Oconee Nuclear Station, Units 1, 2, and 3
Docket Numbers 50-269, 50-270, 50-287
Renewed Operating Licenses DPR-38, DPR-47, and DPR-55

Subject: Response to Requests for Additional Information Concerning Oconee Nuclear Station's Overall Integrated Plan With Regard To Requirements for Spent Fuel Pool Instrumentation

**Response to NRC RAIs Regarding the
ONS Overall Integrated Plan for Reliable Spent Fuel Pool Instrumentation**

FIGURE 1

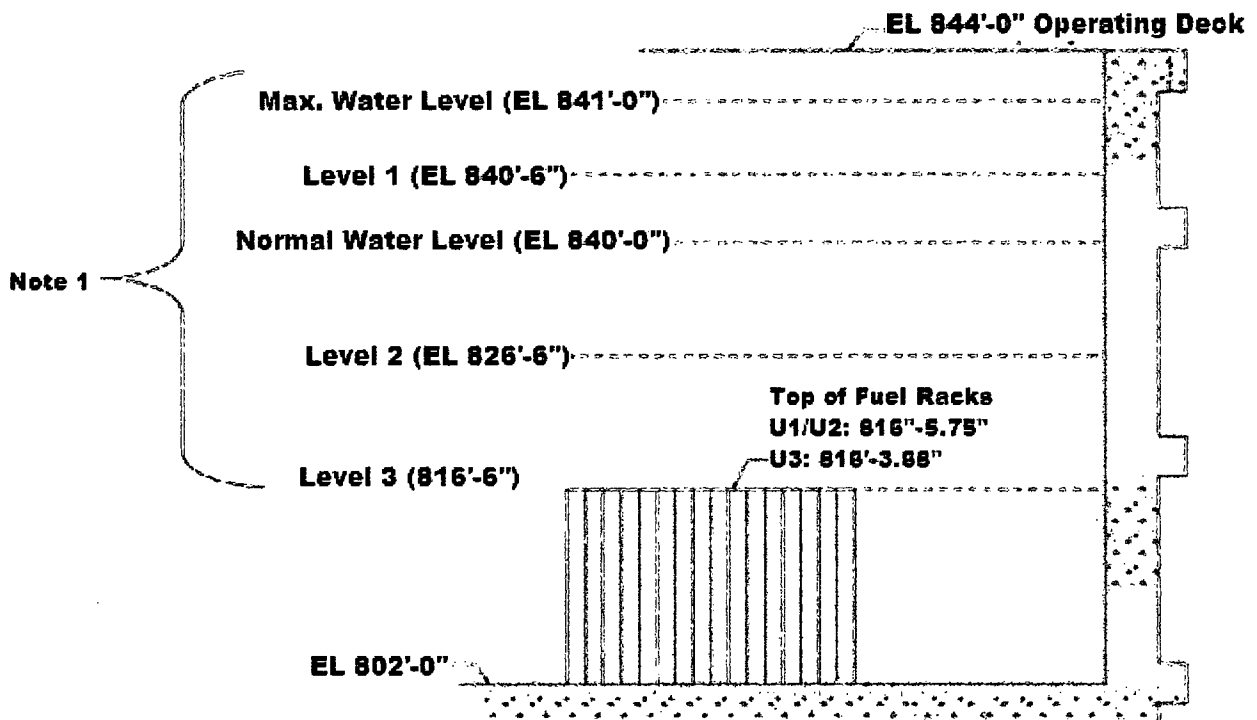
- a) For Level 1, specify how the identified location represents the HIGHER of the two points described in the [Nuclear Energy Institute] NEI 12-02 guidance for this level.
- b) A clearly labeled sketch depicting the elevation view of the proposed typical mounting arrangement for the portions of instrument channel consisting of permanent measurement channel equipment (e.g., fixed level sensors and/or stilling wells, and mounting brackets). Indicate on this sketch the datum values representing Level 1, Level 2, and Level 3 as well as the top of the fuel. Indicate on this sketch the portion of the level sensor measurement range that is sensitive to measurement of the fuel pool level, with respect to the Level 1, Level 2, and Level 3 datum points.

Figure 1 provides the elevations representing Level 1, Level 2 and Level 3, the top of the fuel and the level monitoring range.

Level Range Minimum EL. 816' - 6" to Approximately EL. 841' - 0"

Note 1: Final location of equipment is not determined, but the range will meet or exceed elevations defined by the maximum pool level and the top of the fuel racks.
